North Revilla Final Environmental Impact Statement

Ketchikan Pulp Company
Long-Term Timber Sale Contract

RECORD OF DECISION

VCU: 7400UNIT NUMBER: 4006

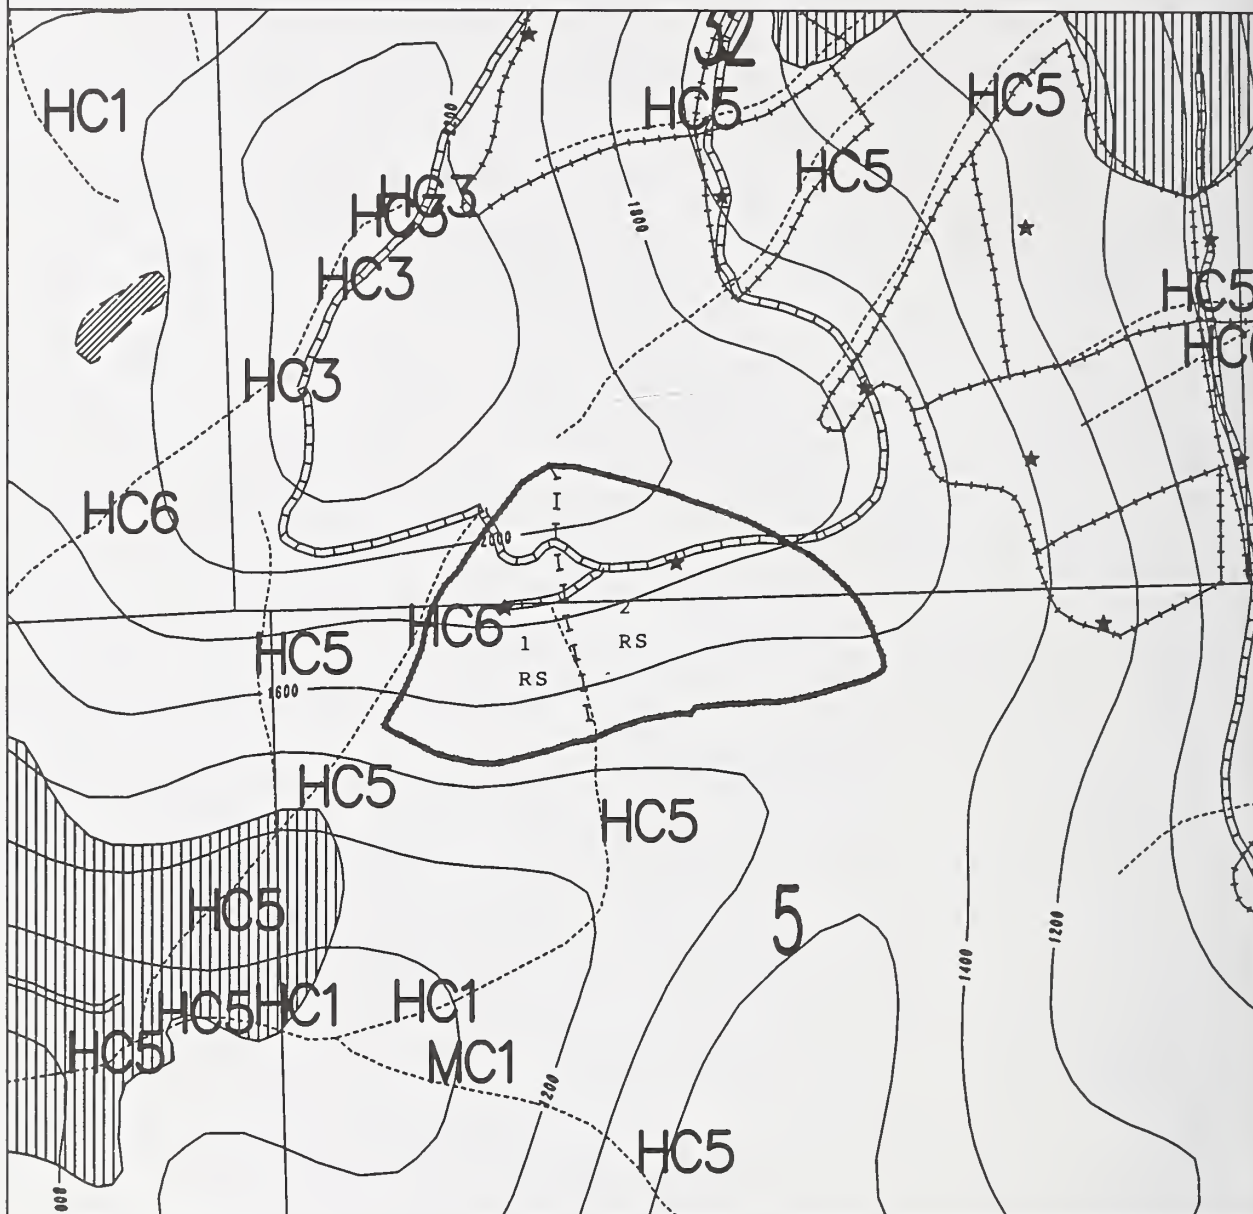
Unit 4006 - Delete road in upper part of harvest unit and the southeast-most setting, and add new road on top of the ridge, to minimize soil disturbance, maintain water quality and improve economic viability.

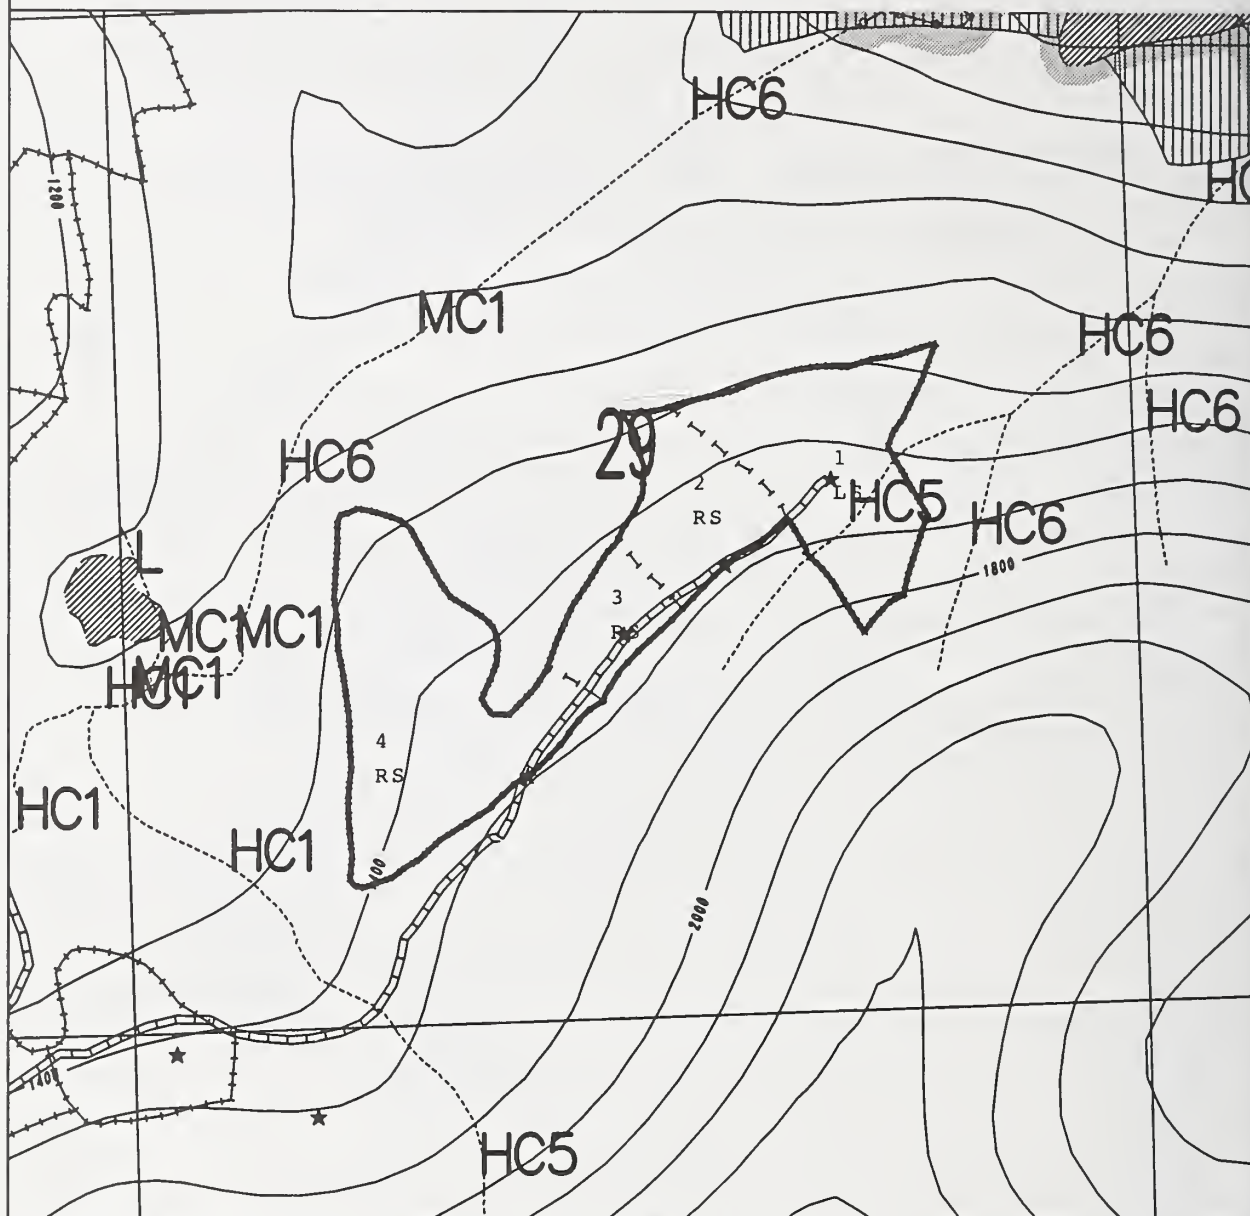
Unit 7551 - Modify road location and delete portion of harvest unit on the east side of the road to minimize soil disturbance and landslide potential. Expand unit on west side of road to avoid isolating timber per new road location, and address windthrow concerns.

VCU: 7380UNIT NUMBER: 8016

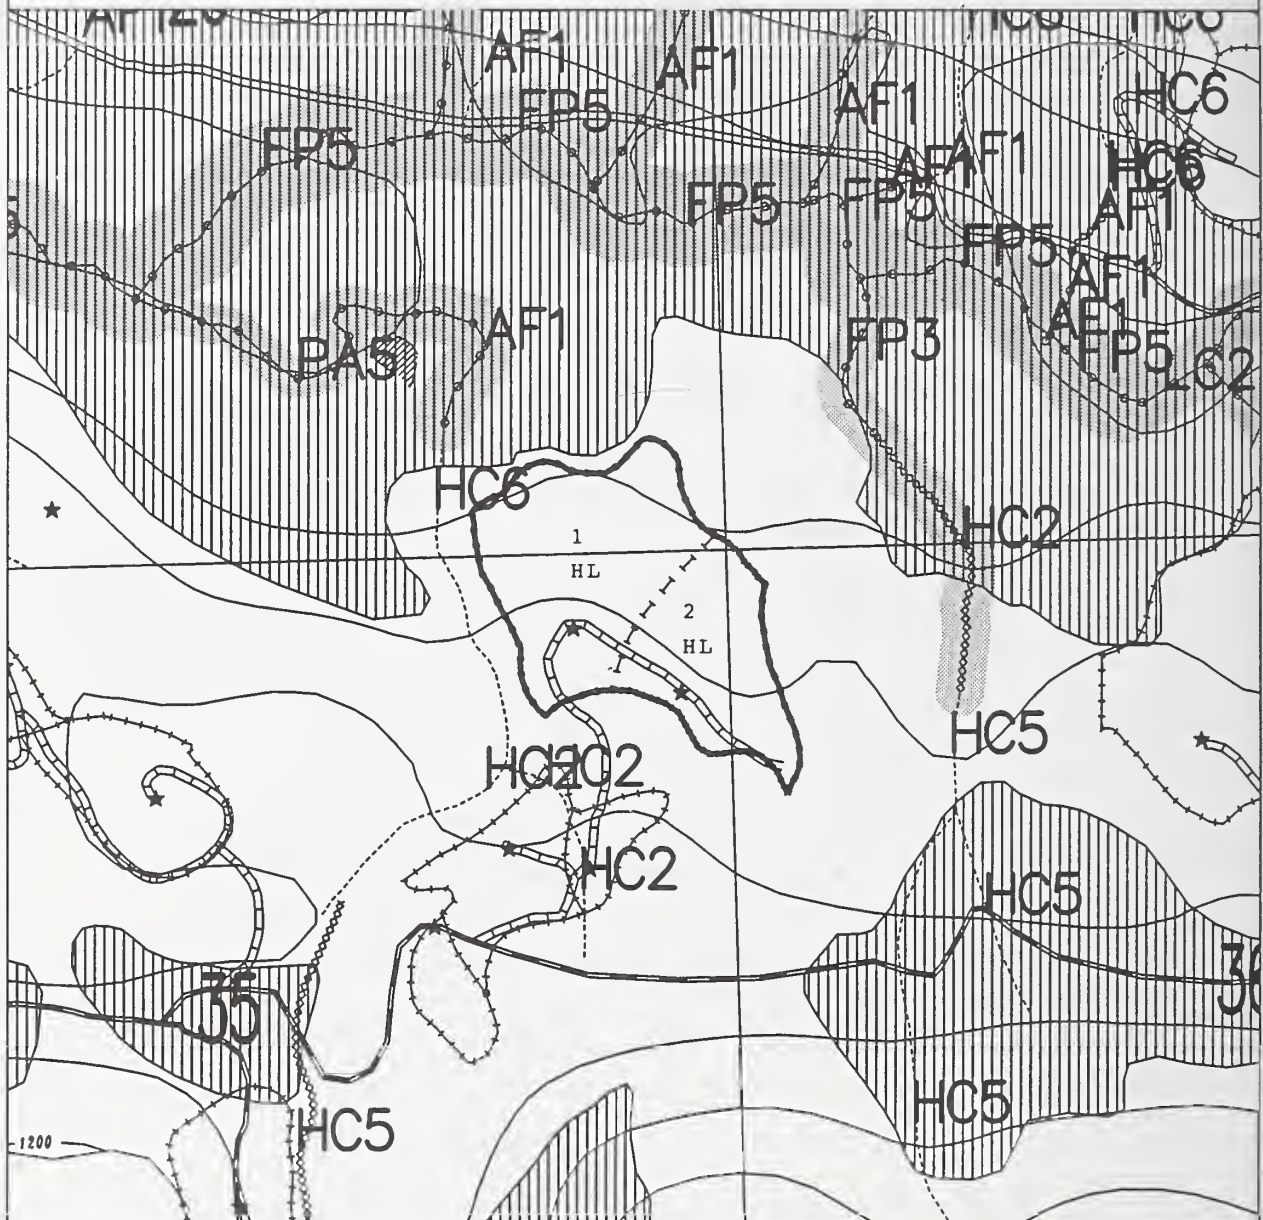
Units 8015, 8016 - Add road segment between harvest units to reduce roading and haul costs, and maintain water quality.

Units 8016, 8073 - Delete northern sections along Margaret Creek wildlife corridor and road segment between harvest units to minimize soil disturbance, maintain water quality and improve economic efficiency. Change yarding system to Running Skyline in 8016, and modify landing to reflect road change.

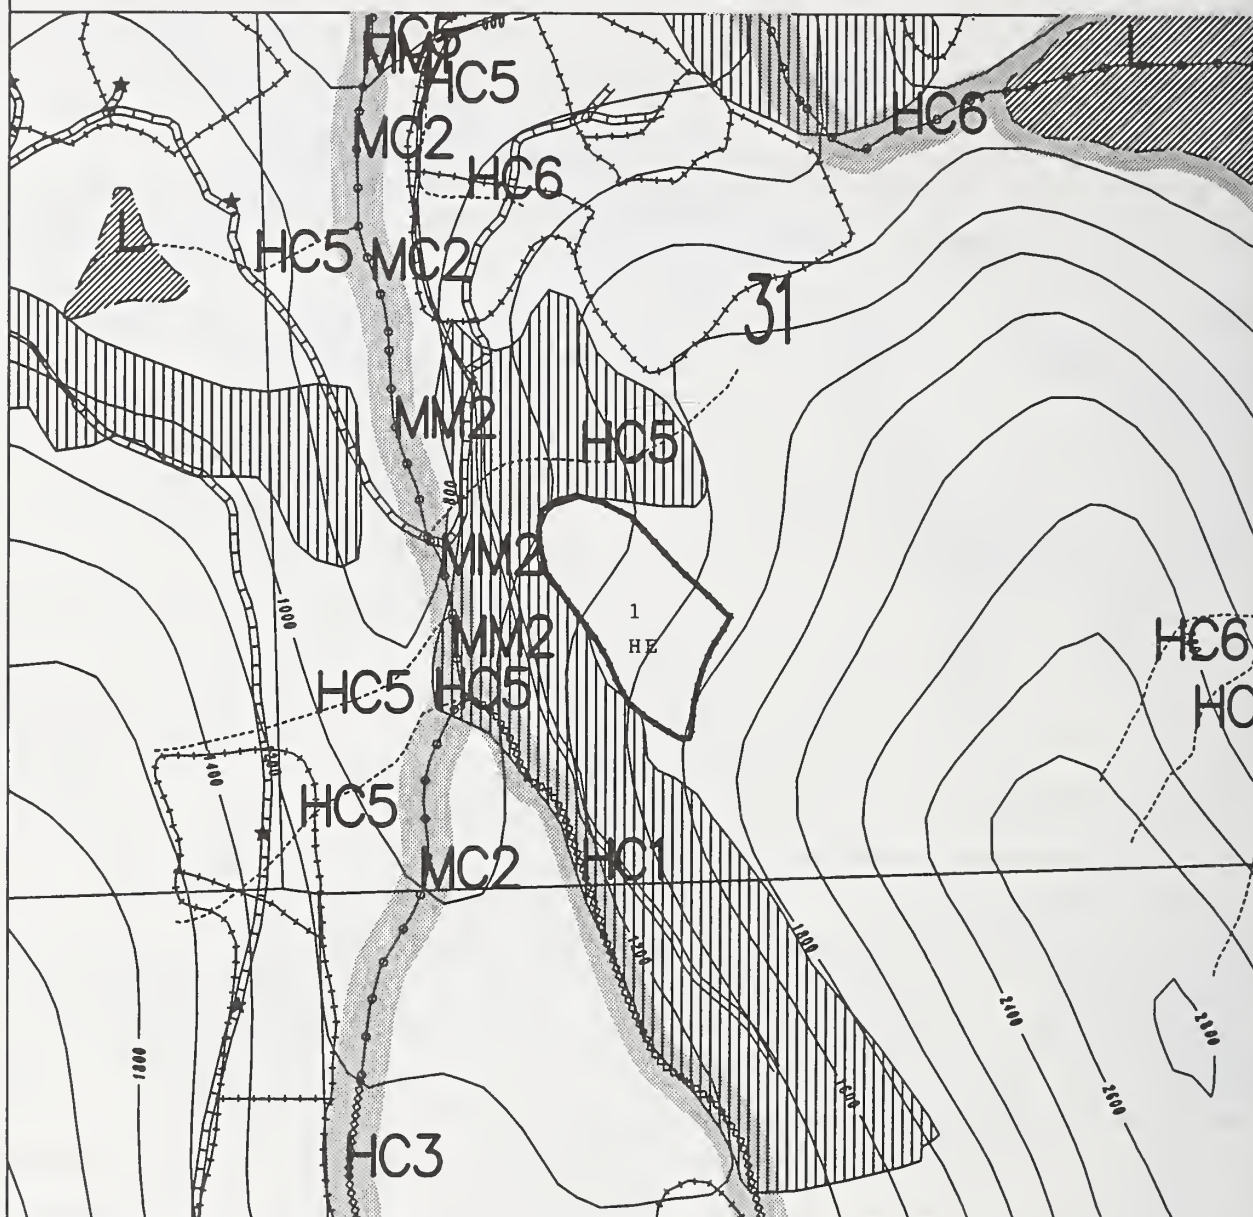
Unit 8024 - Delete road to harvest unit and convert to helicopter yarding system to minimize soil disturbance, and maintain water quality.

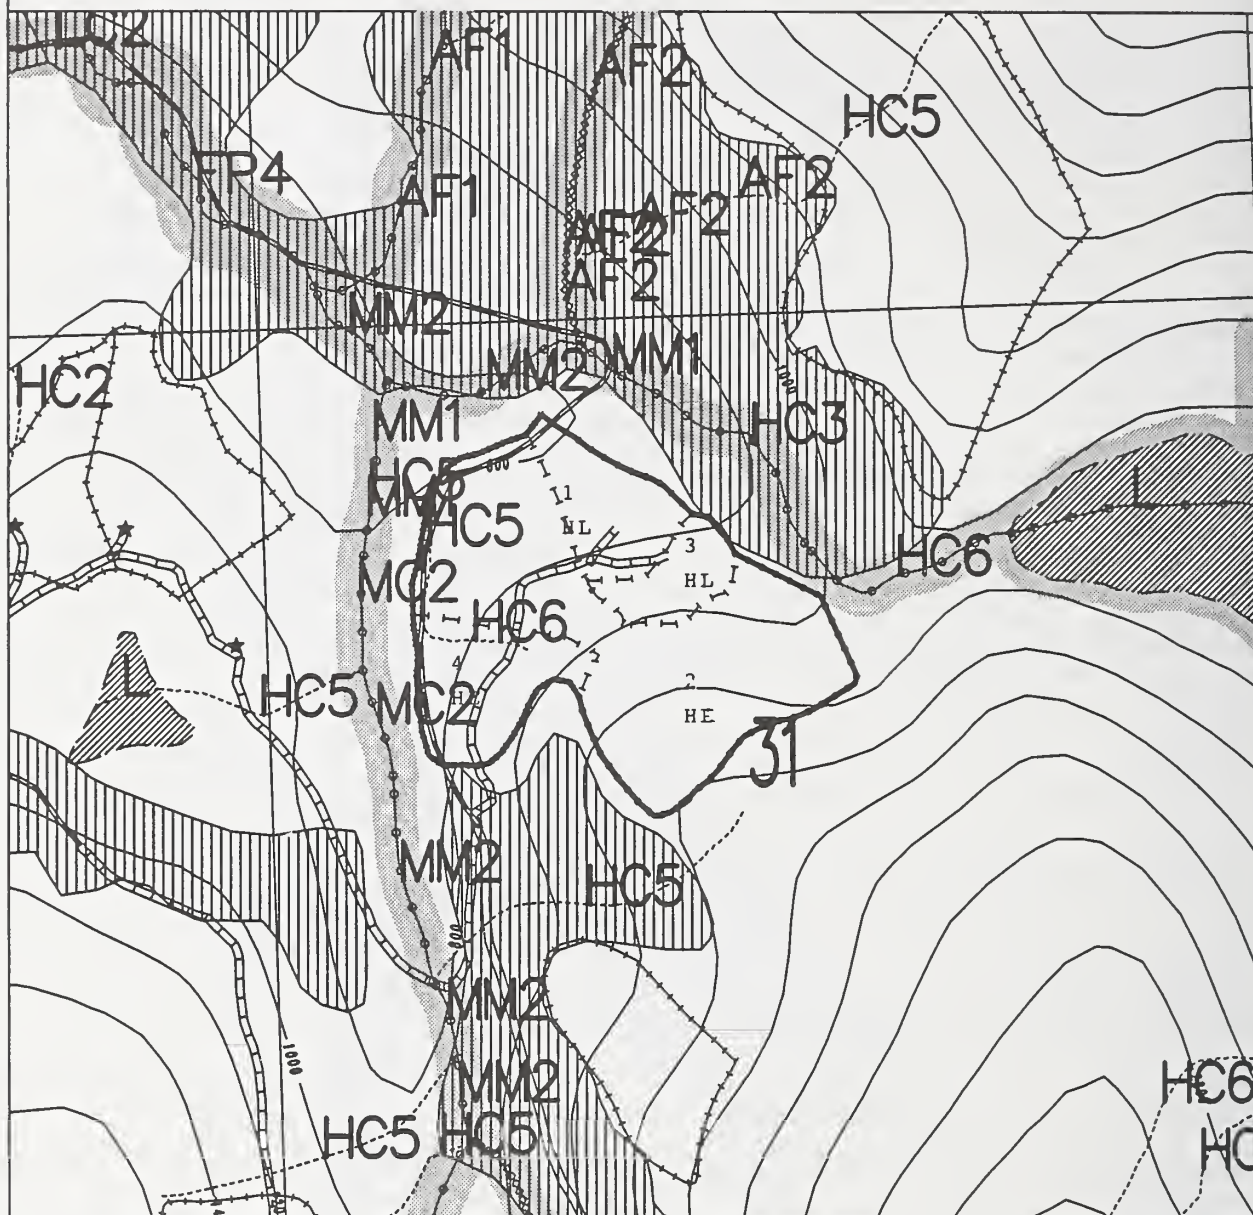
Unit 8022 - Relocate road to access unit from the south, to protect the Class I stream and improve economic efficiency. Delete a portion on the north side of unit along Margaret Creek.

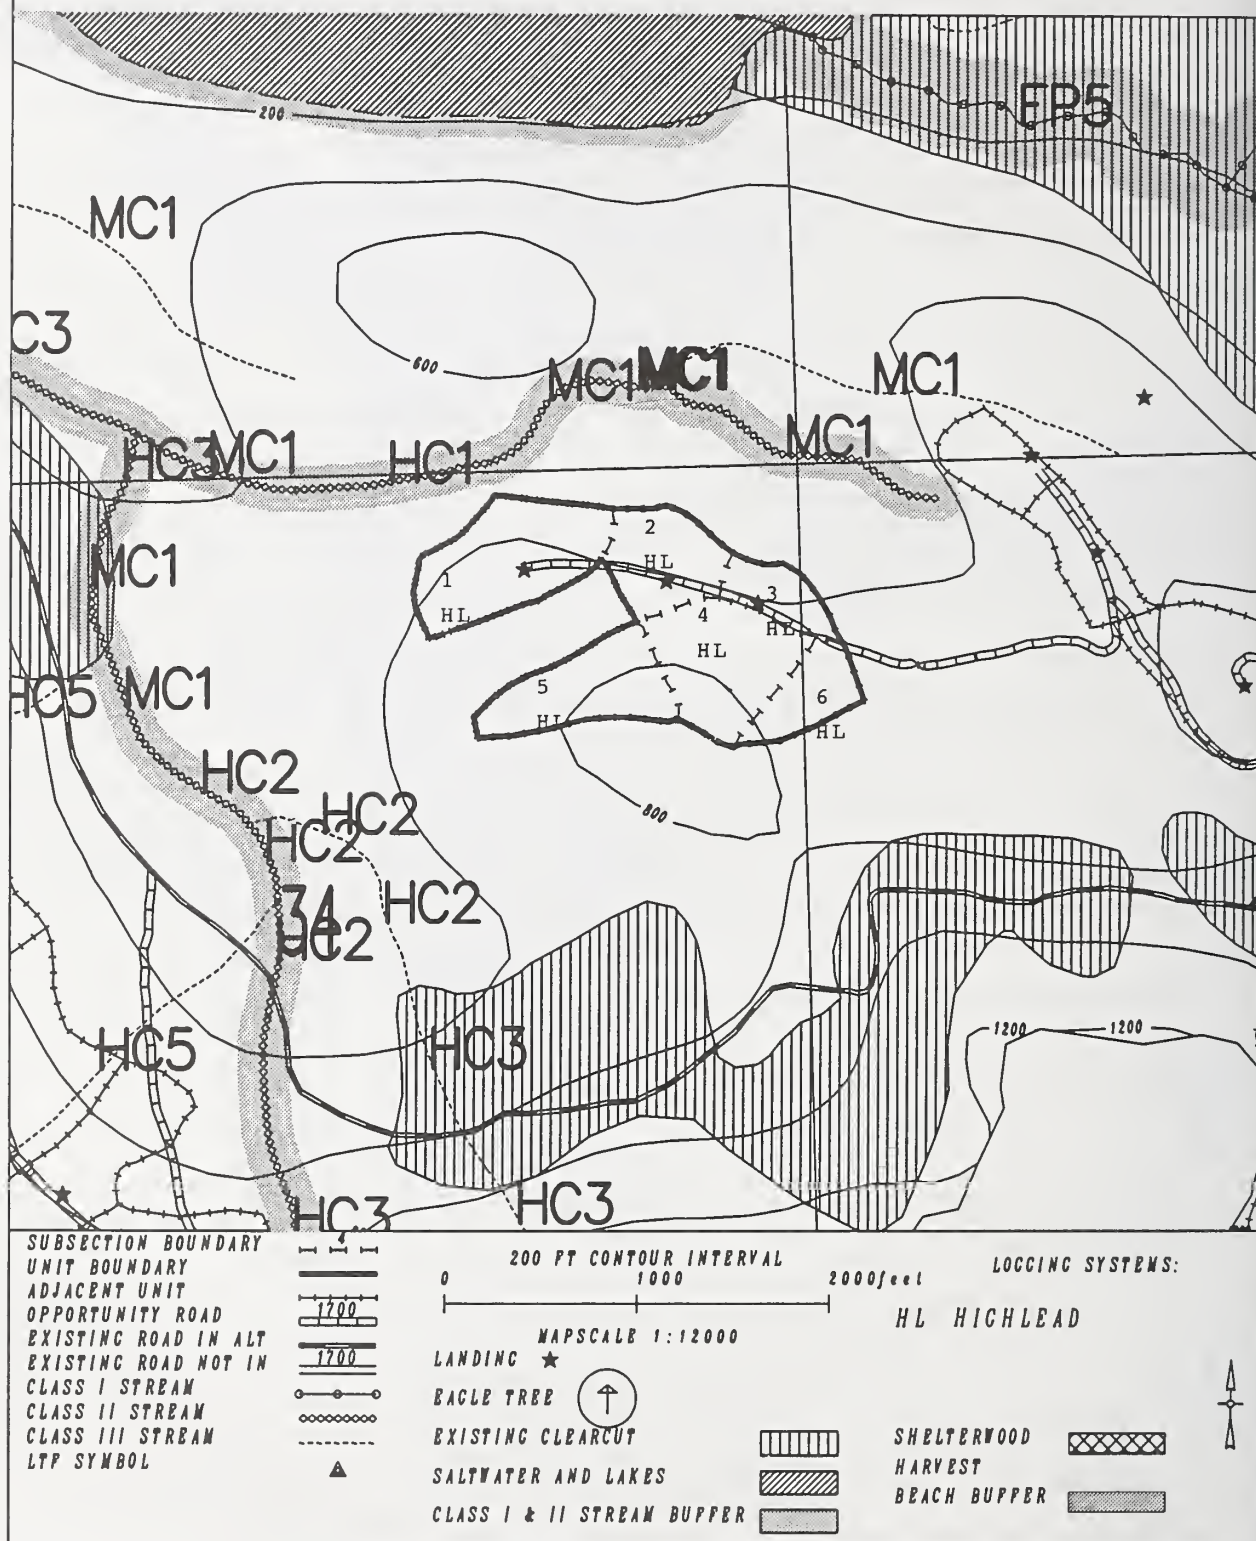
Unit 8071 - Change yarding system to Running Skyline and relocate access within the harvest unit to minimize soil disturbance, maintain water quality and improve economic viability.

VCU: 7380UNIT NUMBER: 8080

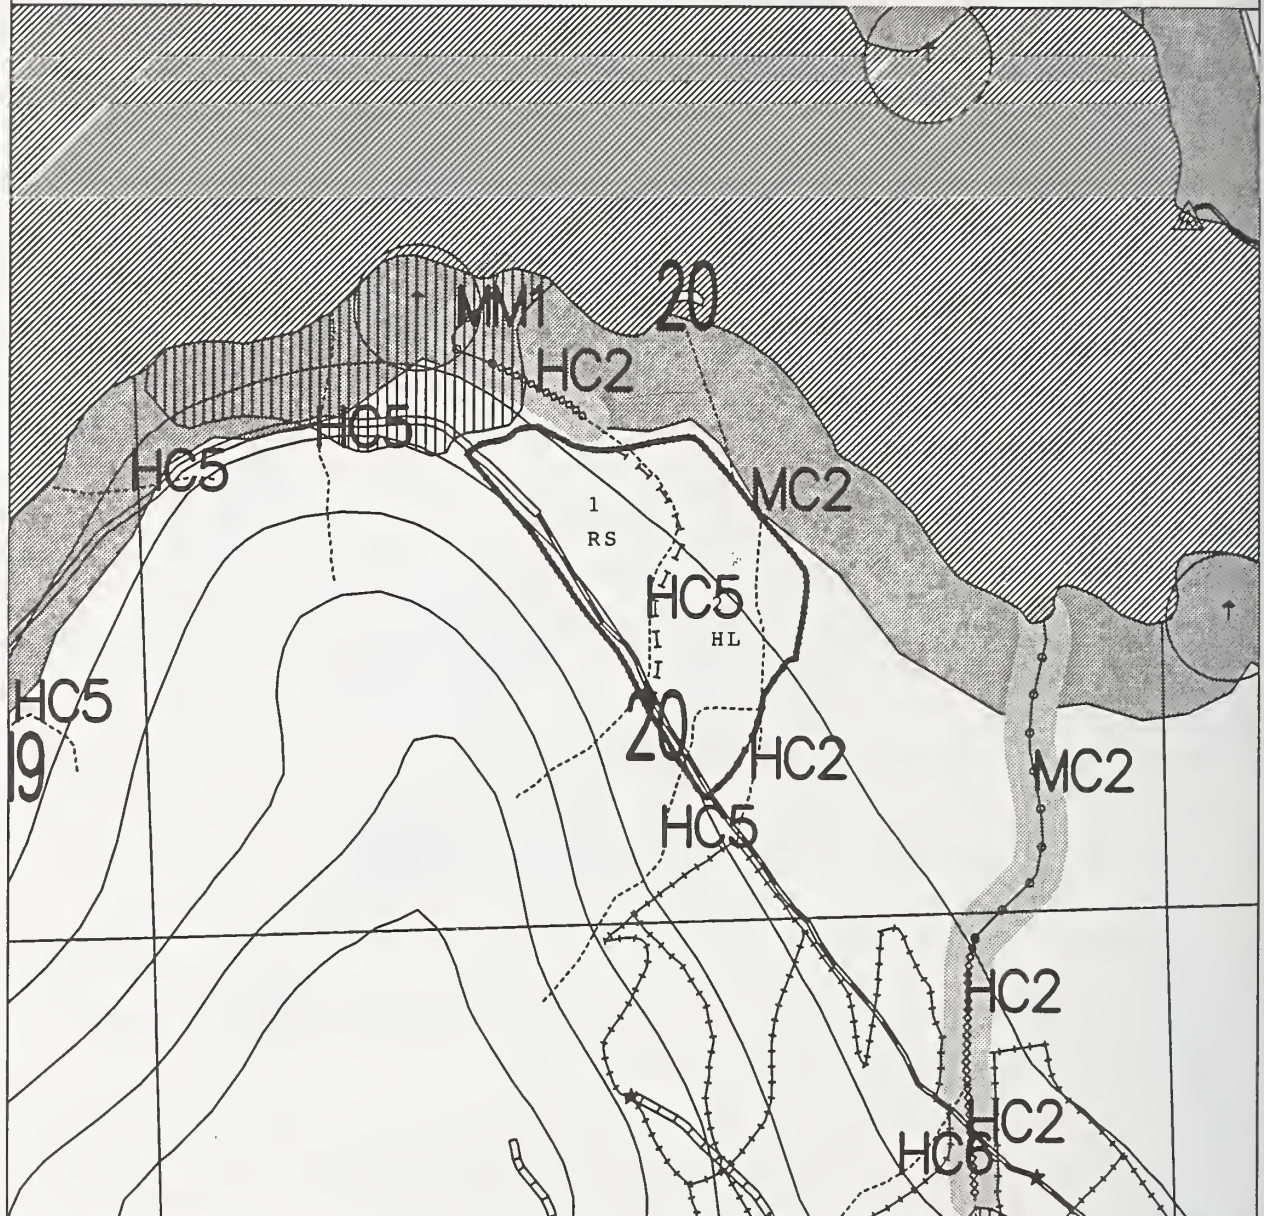
Unit 8080 - Delete road in lower part of harvest unit to minimize soil disturbance and maintain water quality.
